The New Piper Aircraft, Inc.
2926 Piper Drive
Vero Beach, Florida, U.S.A. 32960

SERVICE *No. 1139A* BULLETIN

SB1139A supersedes SB 1139. This revision adds a screw retaining clip to the control wheel installation and adds aircraft models and serial numbers to the effectivity.

**CONTROL WHEEL ATTACHMENT INSPECTION &
RETAINER CLIP INSTALLATION**

Control Wheel Attachment Inspection
Figure 1

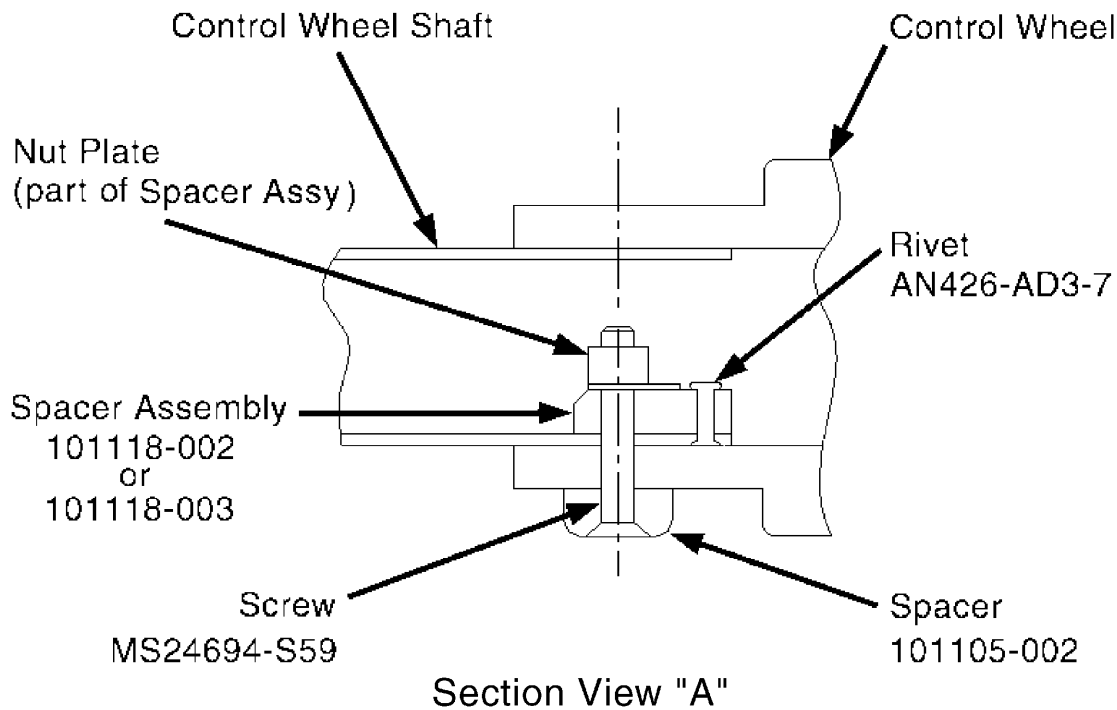
1. Inspect the control wheel attachment screw for proper thread engagement as follows:
 - a) Remove the Piper logo medallion, P/N 474-364, from the front of the control wheel by removing the 4 allen head cap screws, P/N 520-025 (NAS1352-06-12), from the back side of the control wheel to gain access to the inside diameter of the control wheel and control wheel shaft.

- b) Inspect the end of the screw, P/N 410-046, (MS24694-S59) that secures the control wheel to the shaft for proper thread engagement through the nut plate (minimum 1 thread showing past the end of the nut plate).

- c) If insufficient thread engagement is found, replace the screw with the next longer screw, P/N 410-047 (MS24694-S60) during re-assembly.
2. Check the nut plate for sufficient locking characteristics as follows:

- a) Remove the screw, P/N 410-046, (MS24694-S59) and the spacer, P/N 101105-002 (Ref Section View "A") from the control wheel column.
 - b) Remove the control wheel from the shaft.

- c) Re-install the screw into the nut plate located within the control wheel shaft and attempt to fully tighten the screw by hand (without the aid of a screwdriver). If the screw can be fully inserted into the nut plate by hand (one thread past the end of nut), then replacement of the nut plate is required. The nut plate is part of the spacer assembly P/N 101118-002 (On PA-46-350P & PA-46-500TP) or P/N 101118-003 (on all other models). If replacement is required, carefully drill out the rivet, P/N 420-706 (AN426-AD3-7), securing the spacer assembly to the control wheel shaft to remove the spacer assembly. Order and install a new spacer assembly P/N 101118-002 (On PA-46-350P & PA-46-500TP) or P/N 101118-003 (on all other models) and secure to the control wheel shaft using rivet, P/N 420-706 (AN426-AD3-7).

- a) **Thoroughly clean the nut plate on the spacer assembly (P/N 101118-002 or -003), the screw (P/N MS24694-S59 or -S60), and the spacer (P/N 101105-002) with acetone or similar solvent to ensure the parts are thoroughly degreased for application of Loctite thread locking compound.**
- b) Re-install the control wheel onto the control wheel shaft and line up the screw hole in the wheel to the hole in the shaft.

- c) Apply Loctite Primer #7649 and Loctite thread locking compound #271 to the screw threads per the manufacturer's instructions and install the screw, 410-046 (MS24694-S59) or 410-047 (MS24694-S60) and the spacer, P/N 101105-002. Tighten the screw until fully seated.
- d) Re-install the Piper logo medallion, P/N 474-364, and secure to the control wheel using the 2 upper allen head cap screws, P/N 520-025 (NAS1352-06-12), previously removed (lower cap screws to be replaced per Part II).

Figure 2

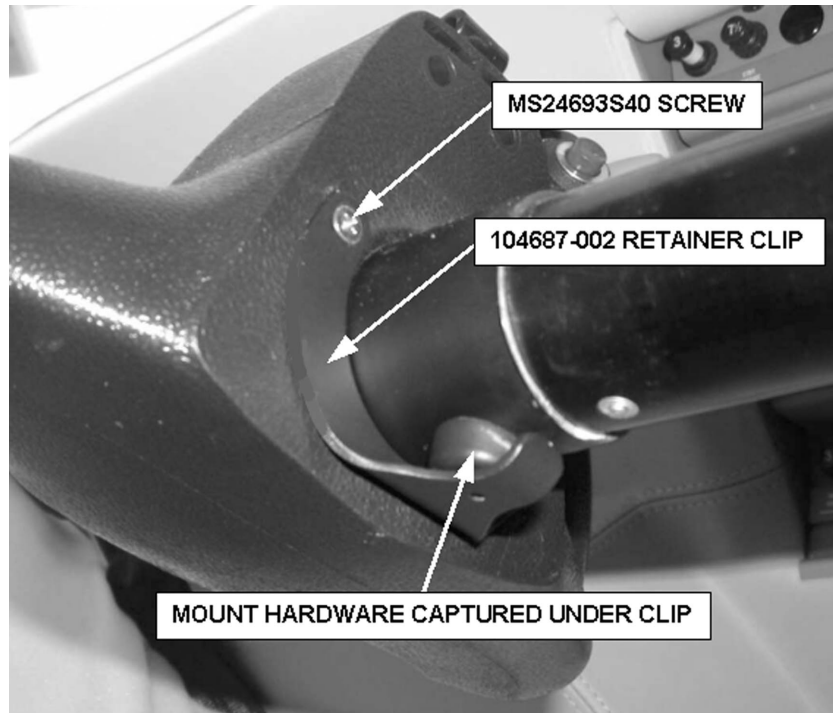
1. From the back side of the control wheel, remove the 2 lower, allen head cap screws, P/N 520-025 (NAS1352-06-12) securing the Piper logo medallion to the front face of the control wheel (if not previously removed during Part I).
2. Install the retainer clip P/N 104687-002 over the control wheel shaft and slide the clip up against the back of the control wheel. Rotate the clip to line up the holes in the clip with the medallion mounting holes on the backside of the control wheel and to allow the lower tab of the clip to cover the head of the control wheel mounting screw.
3. Install 2 screws P/N 416-390 (MS24693S40) to secure the retainer clip in place being careful not to over tighten the screws and damage the logo medallion.
4. Make an appropriate logbook entry indicating compliance with this Service Bulletin.
